London Road Cycle Lane redesign options with modifications if Gosden Hill development goes ahead as proposed. (Revised on 26 10 2024)

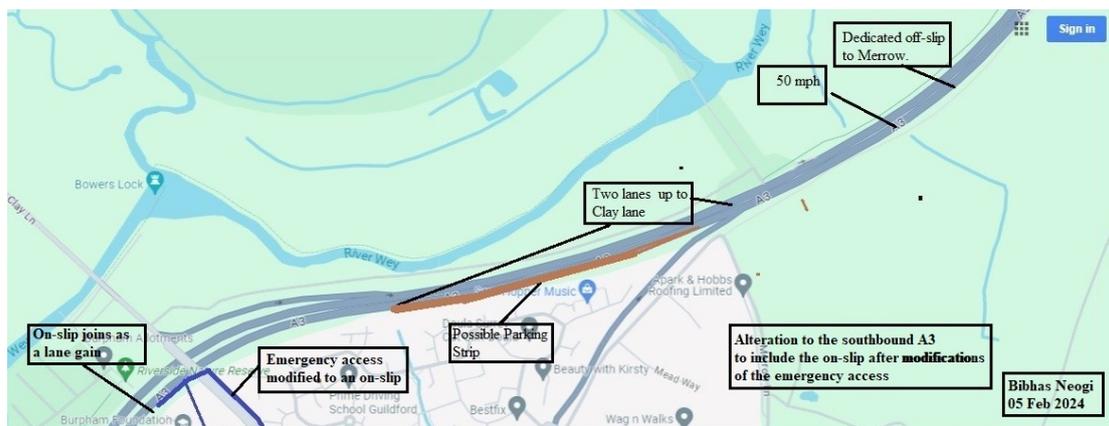
If the stretch between Boxgrove roundabout and the next roundabout to the north were made one-way one lane wide to free up road width for cycle lanes and footways, it would be necessary to find an alternative route for the southbound traffic.

In order to create the southbound on-slip, it would be necessary to make the exit slip road to Merrow a dedicated one. Speed limit should be reduced to 50mph before the exit and the remaining two lanes of the A3 would proceed towards Clay Lane where the on-slip joins the A3 as a lane gain. This is shown in the sketch below.
